Technical Report
on

**EVALUATION OF BLOCK MASONRY WALLS AT
PALO VERDE NUCLEAR GENERATING STATION**

Dr. Ahmad A. Hamid, Ph.D., P.E.
Associate Professor of Civil Engineering
Drexel University
Philadelphia, PA

September 1986

Fig. 1- Floor Spectra at Elevation 74 Ft.

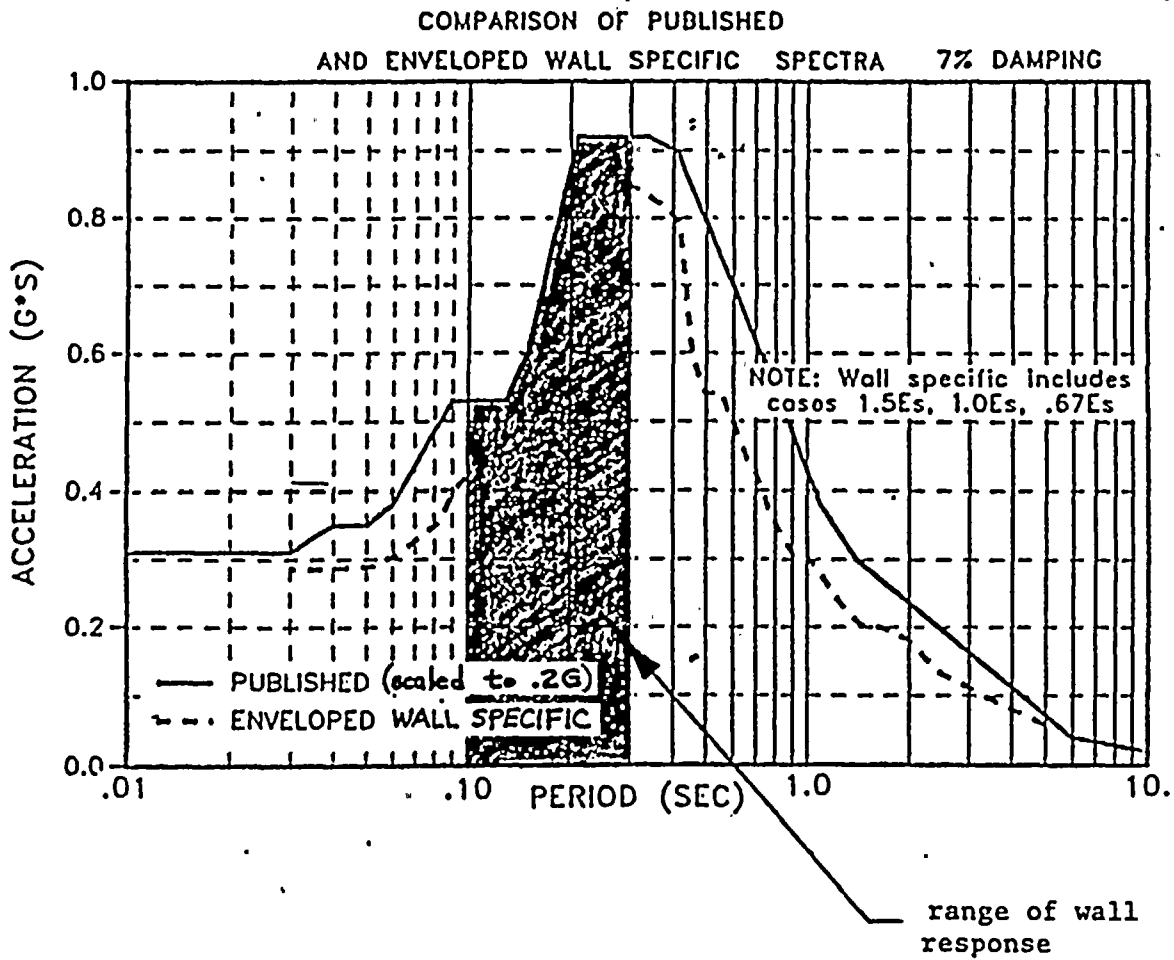
sensitive to the calculated frequency ; see the critical range in the response spectra presented in Fig. 1.

The calculated bond stresses are highly sensitive to the estimated wall stiffness. The stiffness determines the wall frequency which in turn

determines the induced loads and the resulted stresses the wall will experience during an earthquake. The small change in wall frequency results in a large change in acceleration due to the fact that the period of PVNGS walls in question falls in the steep portion of the response spectra curve; see Fig. 1.

A proper design method should conservatively account for the sensitivity of the calculated frequency and the inherent variability in estimating the modulus of elasticity and the effective moment of inertia of such a brittle material as masonry and concrete (7).
